RESPONSE TO REQUEST FOR ADDITIONAL INFORMATION

APR1400 Design Certification
Korea Electric Power Corporation / Korea Hydro & Nuclear Power
Docket No. 52-046

RAI No.: 481-8546

Application Section: 16.3.4, 16.3.5, 16.3.6, 16.3.7, 16.3.9

3.4.10 Pressurizer Pilot Operated Safety Relief Valves (POSRVs)

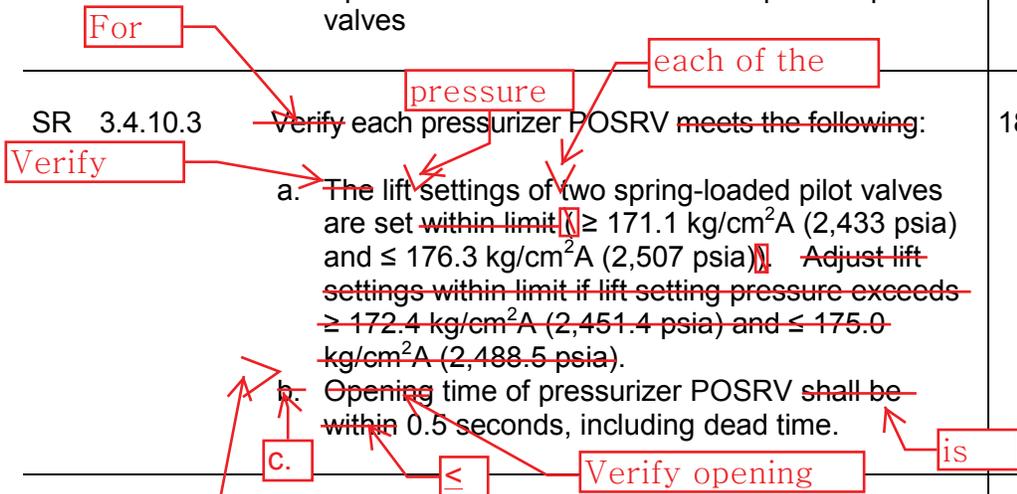
Does “within 0.5 seconds” mean “< 0.5 seconds” or “≤ 0.5 seconds”? Use the appropriate symbol instead of “within” to clarify the POSRV opening time acceptance criterion.

Q5) Does “within 0.5 seconds” mean “< 0.5 seconds” or “ ≤ 0.5 seconds”? Use the appropriate symbol instead of “within” to clarify the POSRV opening time acceptance criterion.

A5) Within (in this context) means ≤ 0.5 seconds. See the mark-ups shown in Attachment 1.

- a. Two spring-loaded pilot valves shall be OPERABLE with lift settings $\geq 171.1 \text{ kg/cm}^2\text{A}$ (2,433 psia) and $\leq 176.3 \text{ kg/cm}^2\text{A}$ (2,507 psia).
- b. The opening time of pressurizer POSRV shall be ~~OPERABLE within 0.5 seconds~~, including dead time

≤
